Application for Works Approval Amendment

Works Approval Number	W6891/2024/1
Works Approval Holder	Greenstone Resources (WA) Pty Ltd
ACN	100 341 599
File Number	DER2024/000052
Premises	King of the Hills Gold Mine LEONORA WA 6438 Legal description – Mining tenements M37/67, M37/76, M37/90, M37/201, M37/222, M37/248, M37/330, M37/410, M37/429, 37/449, M37/451, M37/457, M37/547, M37/548, M37/572, 37/573, M37/574, M37/1105 As defined by the Premises maps attached to the Revised Works Approval.
Date of Report	08 August 2024
Decision	Revised works approval granted

Figure 1: Site layout for TSF4 Stage 7A and Stage 7 expansion and embankment raises

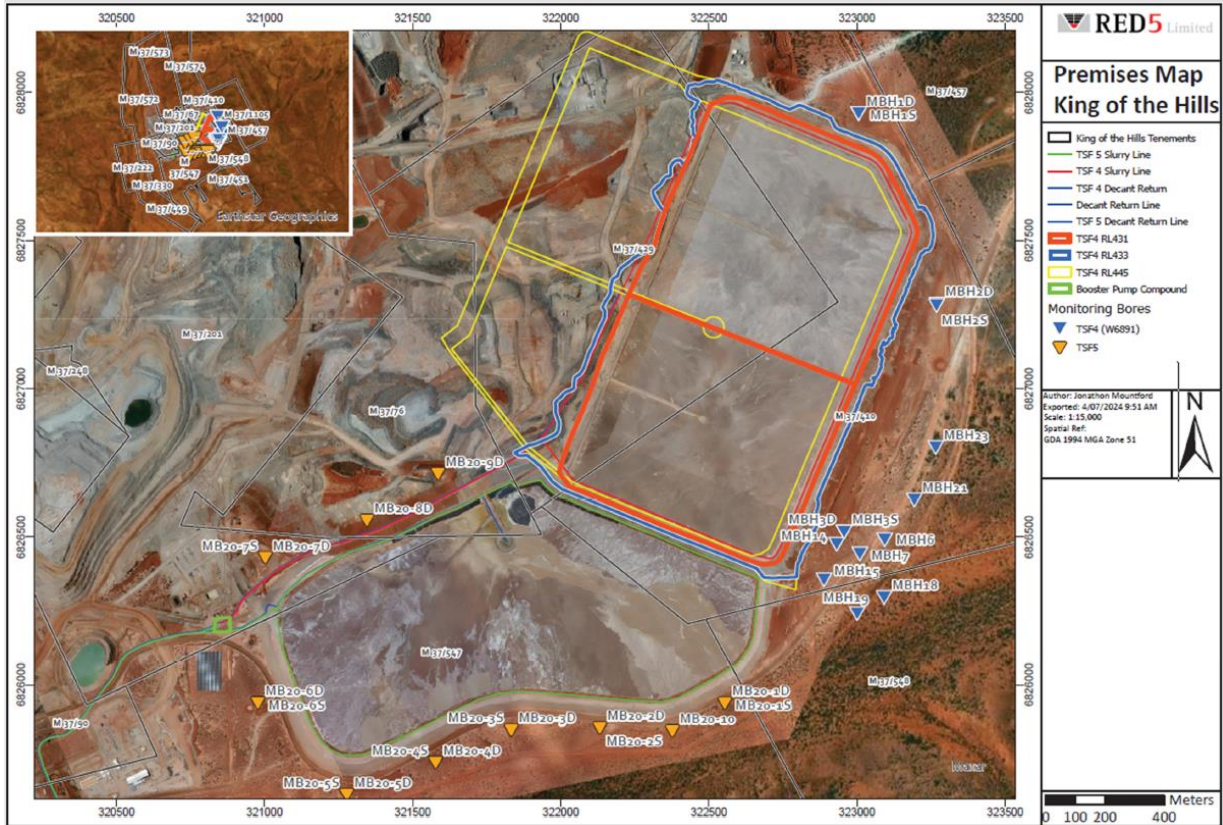
Due to increased tailings production and unavoidable construction delays, the Works Approval Holder urgently required additional tailings storage capacity at TSF4 and had decided to separate the Stage 1 expansion works into two sub-stages, referenced as Stage 7A and Stage 7. TSF4 Stage 7A expansion will involve an embankment raise to only RL 431.0 m, while the Stage 7 expansion will achieve the same embankment height as the authorised Stage 1 (RL 433.0 m) (Figure 1). Doing so was intended to allow the Works Approval Holder to commence time limited operation of TSF4 Stage 7A promptly, while completing construction of Stage 7. The proposed change in staging would not significantly alter the fundamental design, capacity, safety, or operational parameters of TSF4.

Based on advice from the department, the Works Approval Holder submitted an application on 9 July 2024 to amend works approval W6891/2024/1 under section 59B of the *Environmental Protection Act 1986* (EP Act). The amendment is limited only to modifying the staging of infrastructure construction, such that the revised works approval reflected the modified staging of Stage 7A and Stage 7 at TSF4. The amendment does not retrospectively approve completed
